PRODUCT CHANGE NOTIFICATION (PCN)

AMJE0909-0500-BNB-24
MODULAR CABLE

CHANGE NOTIFICATION: PCN 20220509_AMJE0909-0500-BNB-24

DESCRIPTION OF CHANGES:
CHANGE OF DATA SHEET
CHANGE OF DATA SHEET
New Draw.-No. ASS_7945_CArev02

AMJE0909-0500-BNB-24 OLD VERSION

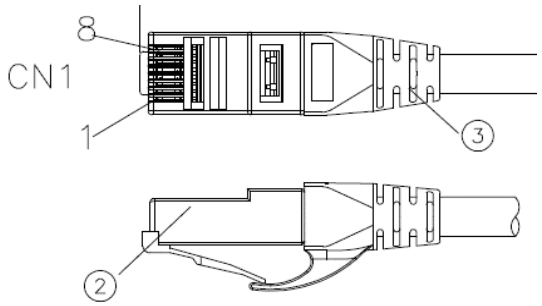
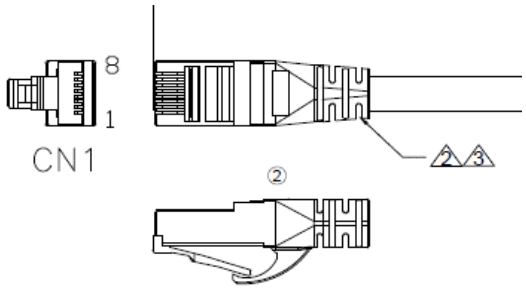
REASON FOR CHANGE:
CHANGE OF PRODUCT LOCATION
CHANGE OF PRODUCT LOCATION

③	Molding	PVC 45P Color: see order code	NA	KG
②	CONNECTOR	RJ45 8P8C two fork Short type 3u" gold plated	2	PCS
①	CABLE	CAT6 UTP (24AWG*1PR)*4+PVC OD=5.8±0.3MM Color: see order code	NA	MM
NO:	NAME	DESCRIPTION	Q'TY	UNIT

3	Molding	PVC 65P Color: see order code ②	NA	KG
2	CONNECTOR	RJ45 8P8C PLUG 3u" gold plated ②	2	PCS
1	CABLE	CAT6 U/UTP (24AWG*1PR)*4+Cross+PVC Jacket OD=5.8± 0.3MM Color: see order code ②	NA	MM
NO:	NAME	DESCRIPTION	Q'TY	UNIT

Drawing-No.
ASS 7945 CA

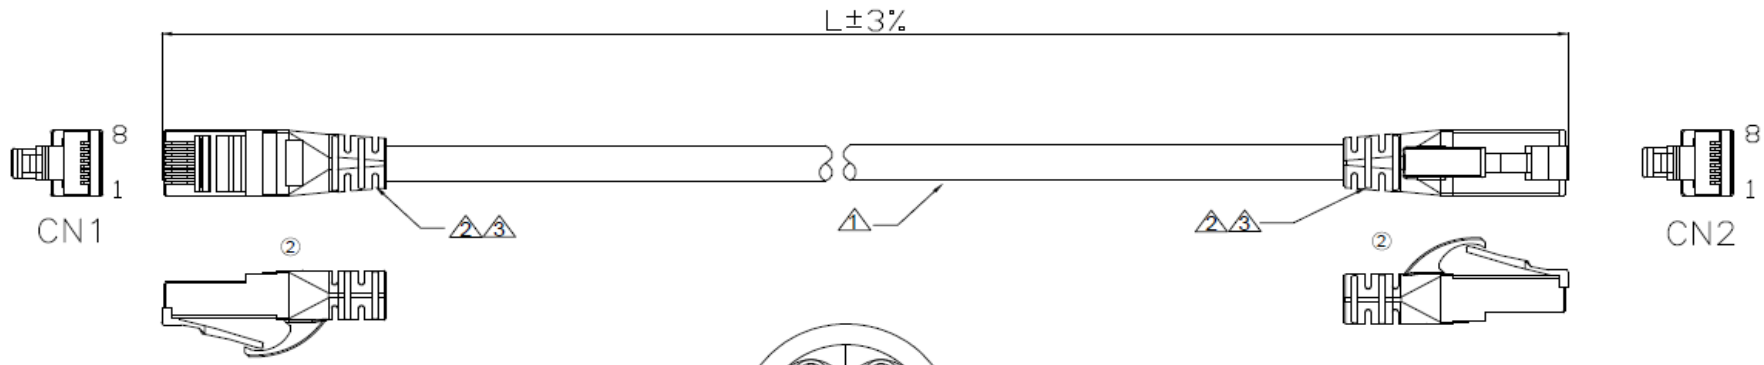
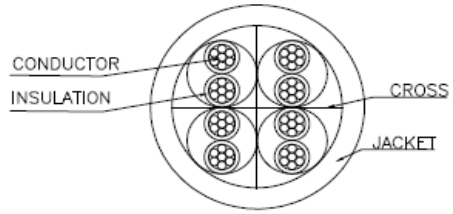
Id.	Modification	Date	Name
②	Change the plant	09.05.2022	Luca
①	Update the WSW order code	02.06.2017	Amy
⓪	Drawn	30.03.2017	Amy

NO:	NAME	DESCRIPTION	Q'TY	UNIT
3	Molding	PVC 65P Color: see order code ②	NA	KG
2	CONNECTOR	RJ45 8P8C PLUG 3u" gold plated ②	2	PCS
1	CABLE	CAT6 U/UTP (24AWG*1PR)*4+Cross+PVC Jacket OD=5.8± 0.3MM Color: see order code ②	NA	MM
